SUBMITTAL SUMMARY REPORT
MajorSite-000319-2026

PLAN NAME:	Black Label Marine	**LOCATION:**	4211 NW BLITCHTON RD OCALA,
APPLICATION DATE:	02/06/2026	**PARCEL:**	21548-000-00
DESCRIPTION:	Project consists of infrastructure, paving, building and associated stormwater conveyance to serve a boat dealership

MAJOR SITE PLAN OF BLACK LABEL MARINE

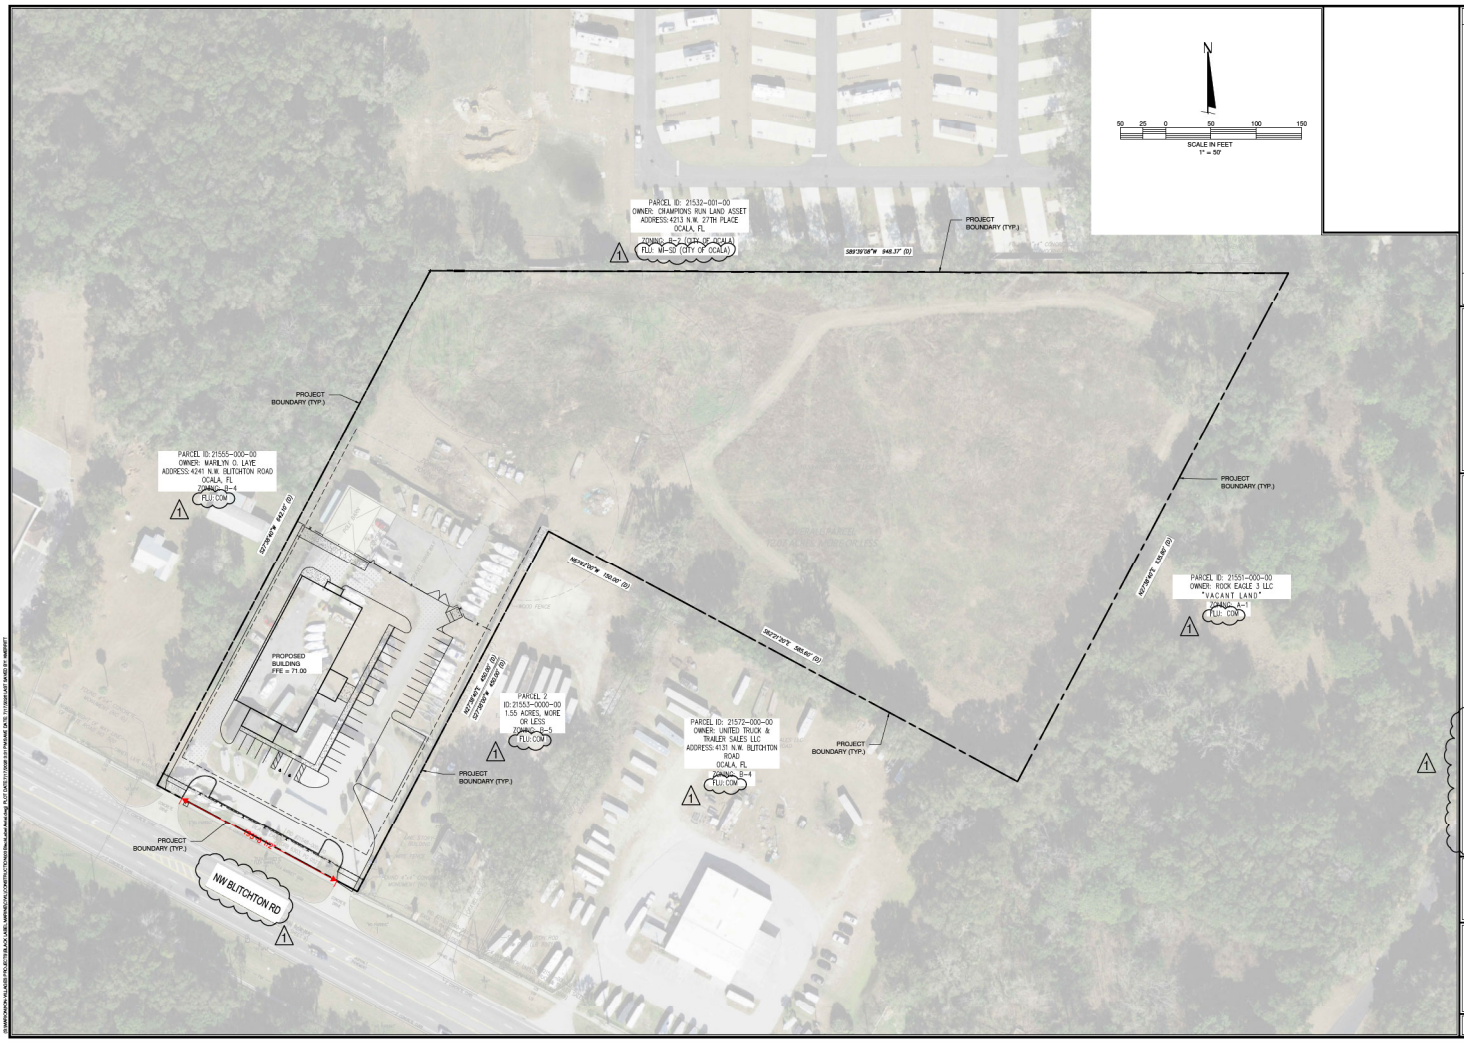
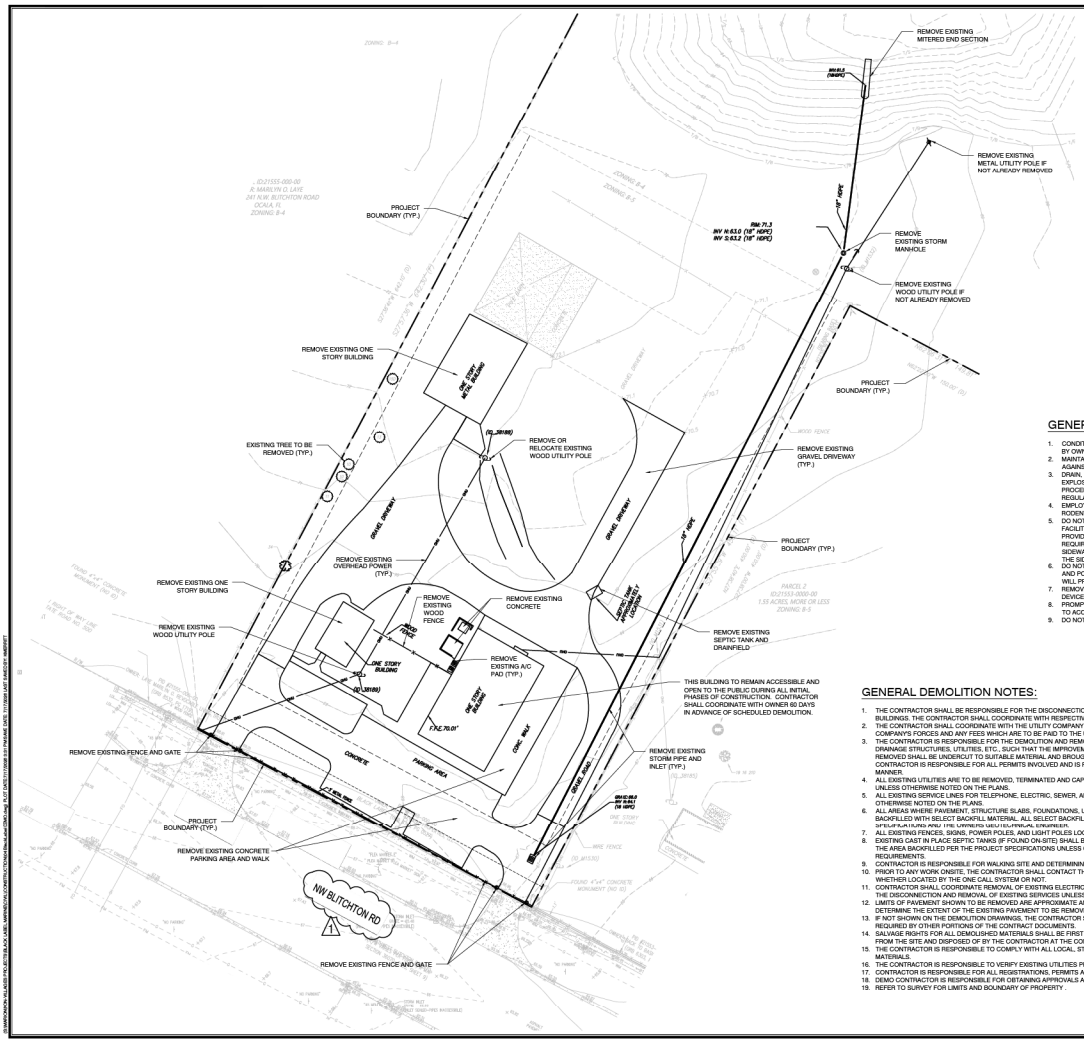
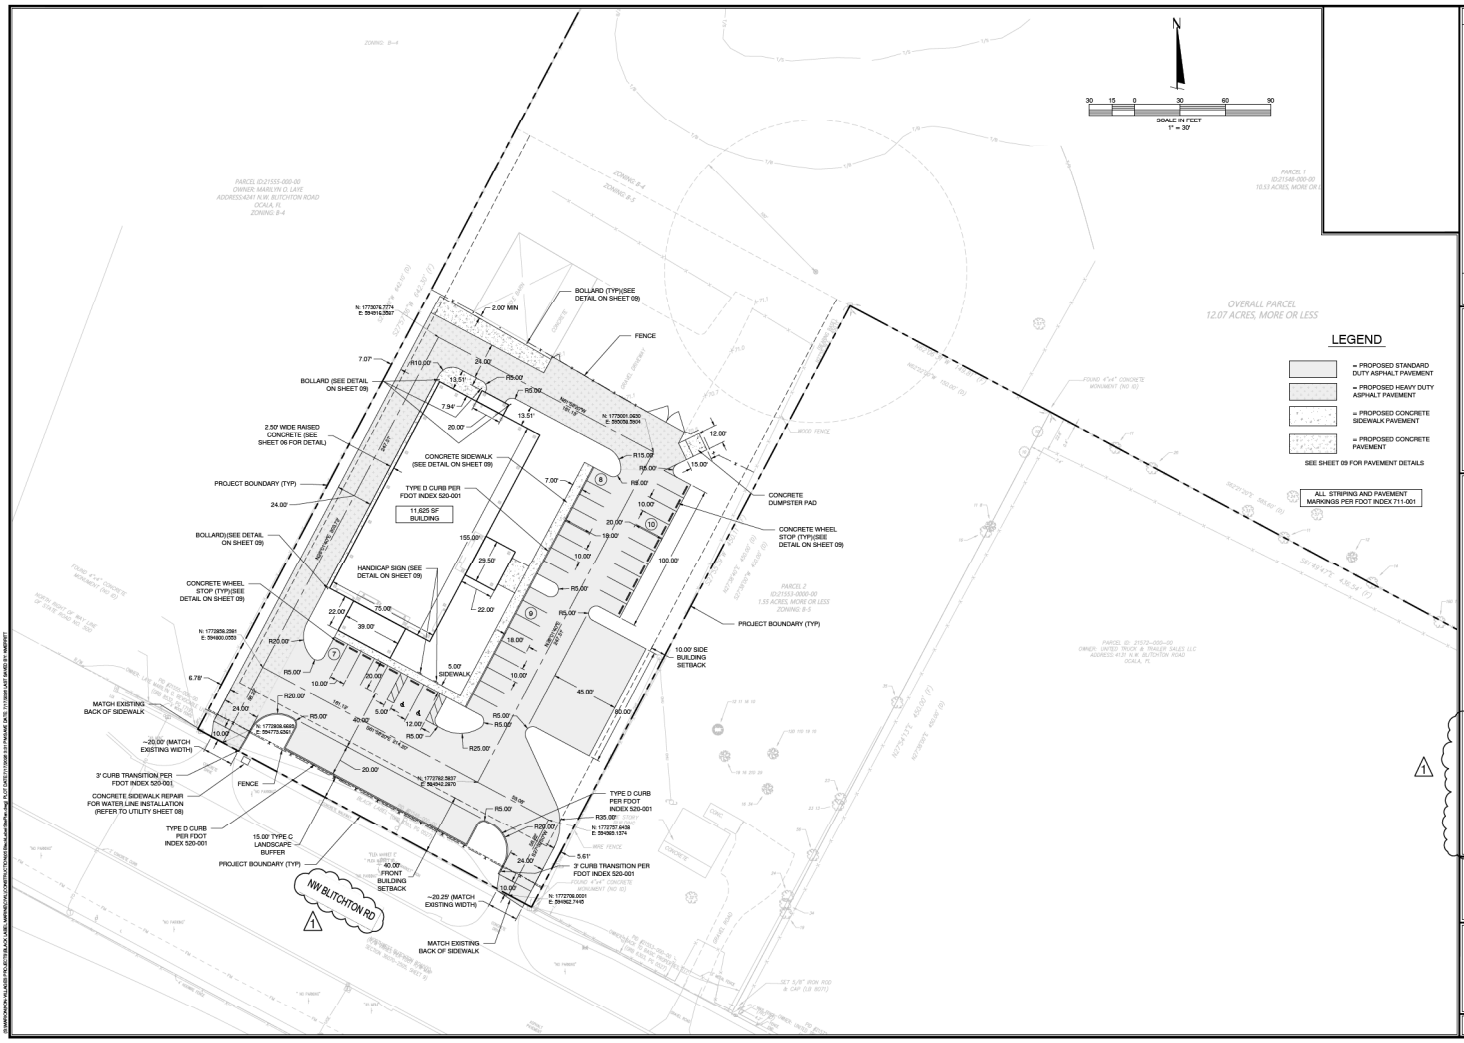
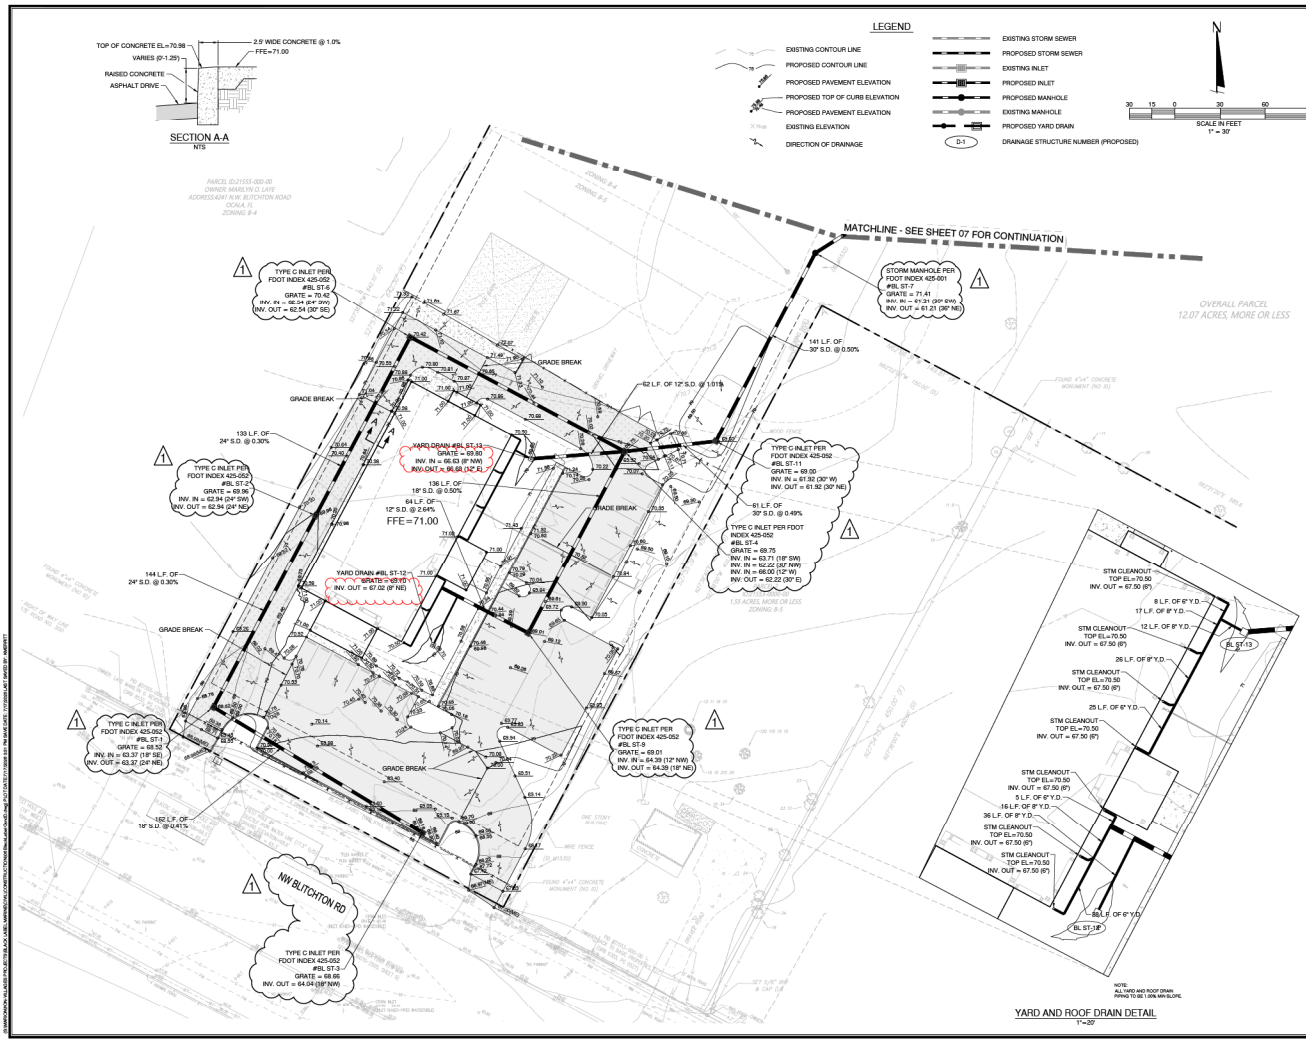
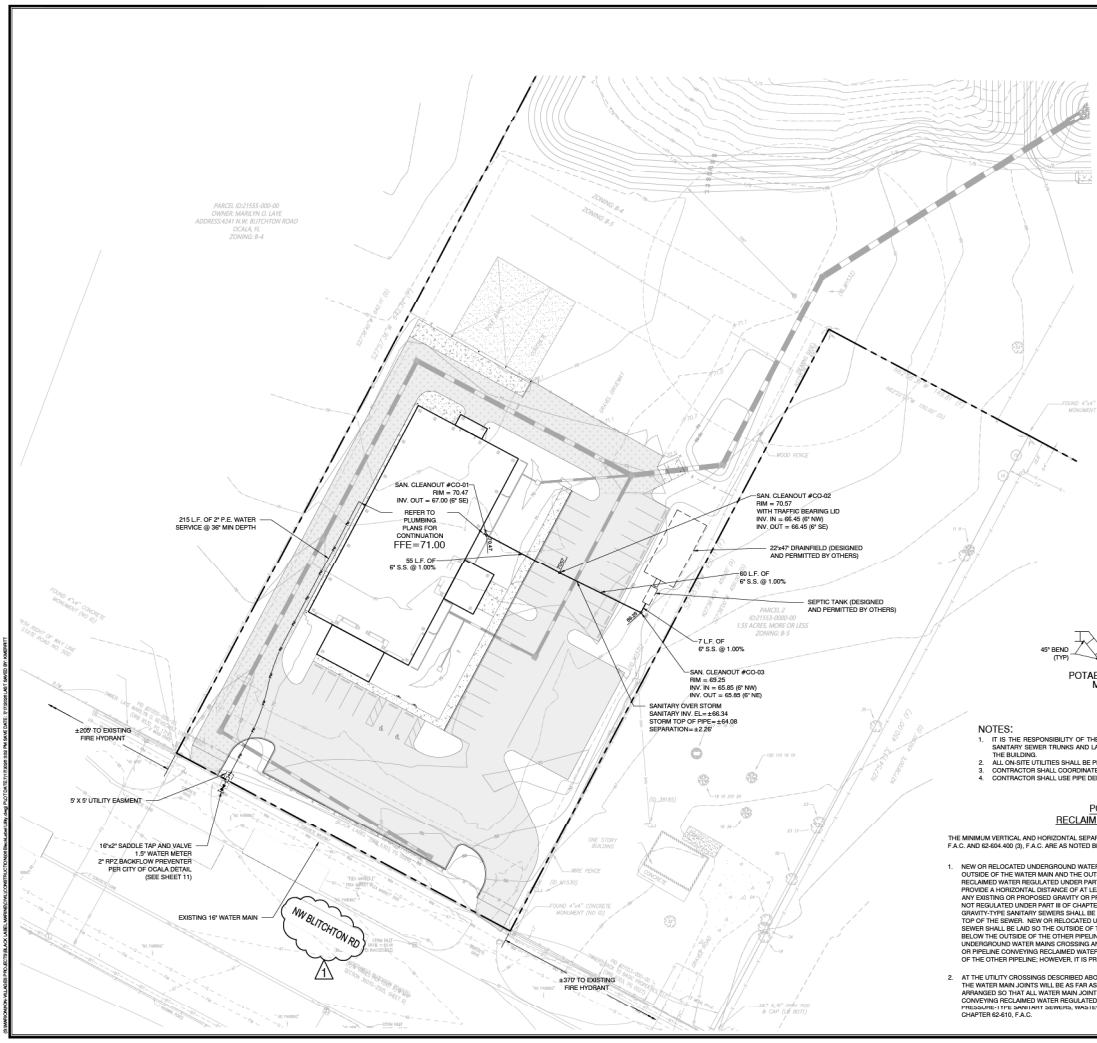
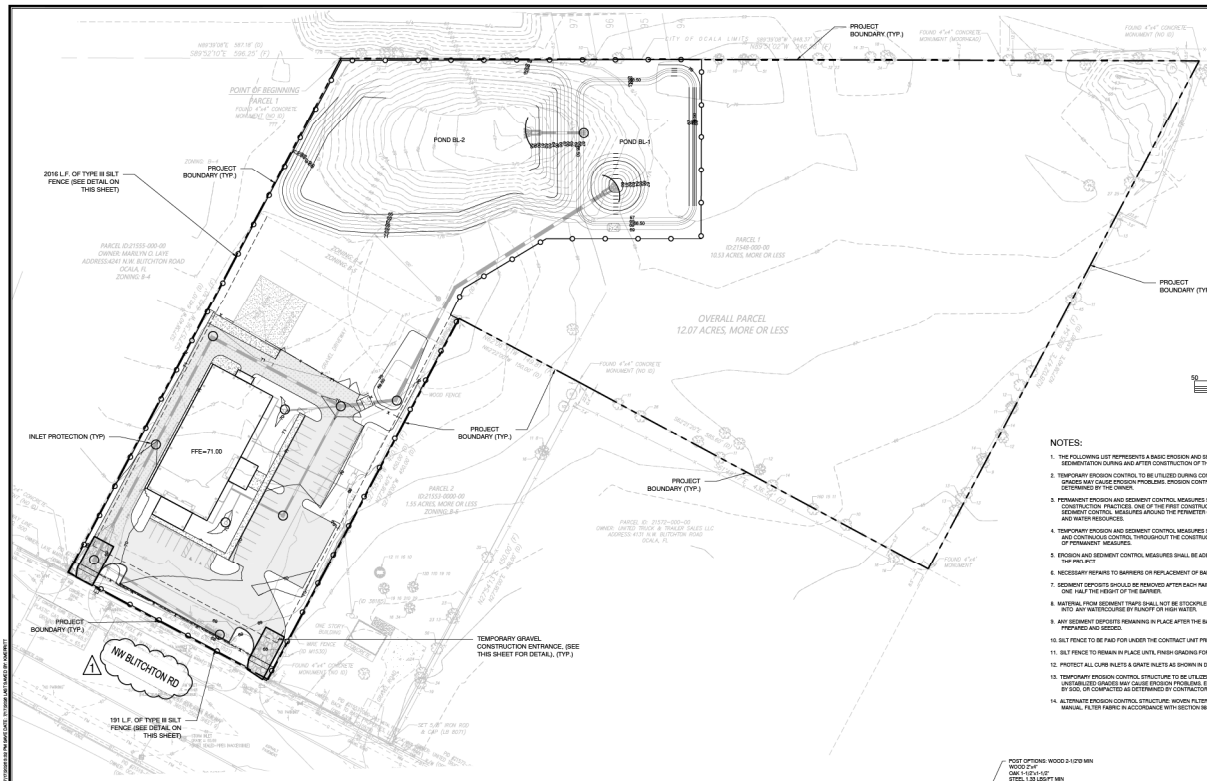
Corrections Additional 911 Comments (**Resolved**) - **Corrective Action:** Incorrect Road Names - On Combined Plans S&S, Sheets 03, 04, 05, 06, 08, 11 have NW Blitchton Rd incorrectly labeled as US Highway No. 27. On Landscape and Irrigation Combined ESS, Sheets 02, 03 have NW Blitchton Rd incorrectly labeled as US Highway No. 27 but it will not allow me to make changemarks. Be sure to correct the road names on both plan sets.

BLACK LABEL MARINE
MAJOR SITE PLAN
MARION COUNTY, FL
POND PLAN, SECTION, AND DETAIL

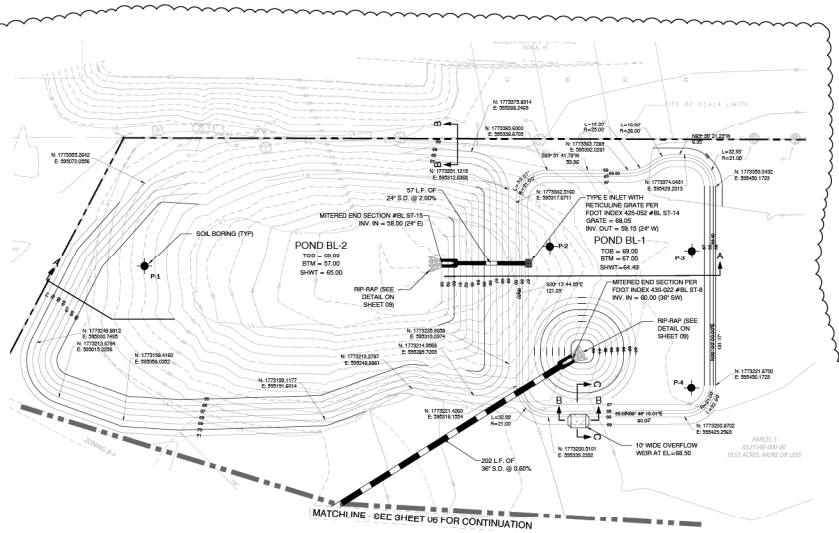
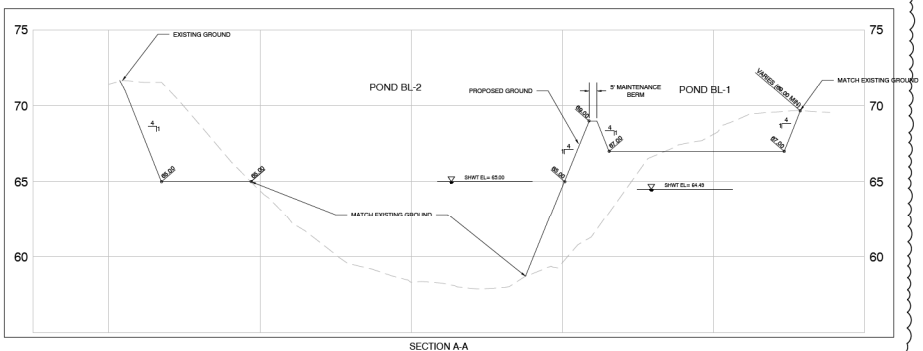
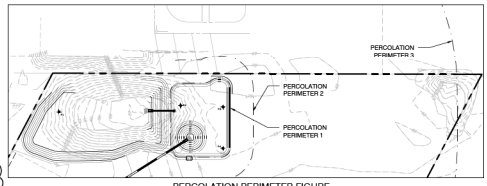
6.13.2.A.3 - Retention/Detention Design Parameters (**Not Resolved**) - Plans need to appropriate vegetative cover on the pond bottom.
